1 Overview and Background on Community Engagement

This section provides summaries of significant comments received during the public comment period and responses to those comments. This document breaks out comments into the following sections

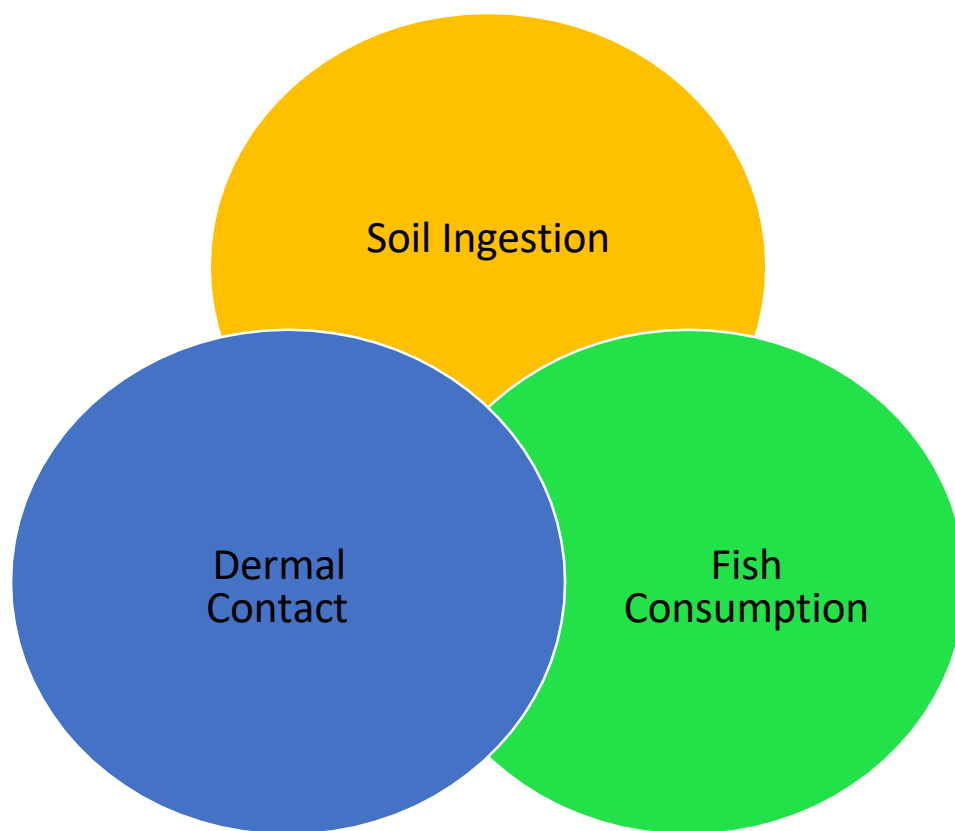
2.3.70 Comment: Region 6 has invented a generic hypothetical compound that they designate as a “TEQ” and to which they ascribe the physicochemical and pharmacokinetic properties of 2,3,7,8-TCDD. As shown in Figure 1, the predominant PCDD/F congeners at the site are OCDD and 2,3,7,8-TCDF, however, the chemical-specific parameters used in Region 6’s calculations were all only based on 2,3,7,8-TCDD properties assigned to the hypothetical “TEQ”. This introduces a significant amount of error in the use of these PRGs for any chemical other than 2,3,7,8-TCDD and obviates the use of the PRGs either to derive cleanup goals or to characterize PTW unless they are limited to application to 2,3,7,8-TCDD.

Response: *As noted in several comment responses, based on the fingerprinting exercise the primary dioxin and furans found in the waste are the 2,3,7,8-TCDD and TCDF congeners. Consequently, using the TCDD as a surrogate for determining the half-life is appropriate. While it is acknowledged that estimates of half-lives of TCDD (or any other organic compound) are difficult, and range often by orders of magnitude, it has to be acknowledged that dioxins and furans are long-lived and persistent in the environment. EPA maintains that the use of an armored cap will be inadequate to contain the pulp waste over the long-term. Whether that long-term is 100 or 500 years, it is more likely years or at most decades before a major hurricane hits the area with the potential of significant damage to a cap and release of the*

dioxins and furans in the pulp waste to the surrounding environment. Removal of the pulp waste (Alternate 6N) was therefore selected as the appropriate remedial action.
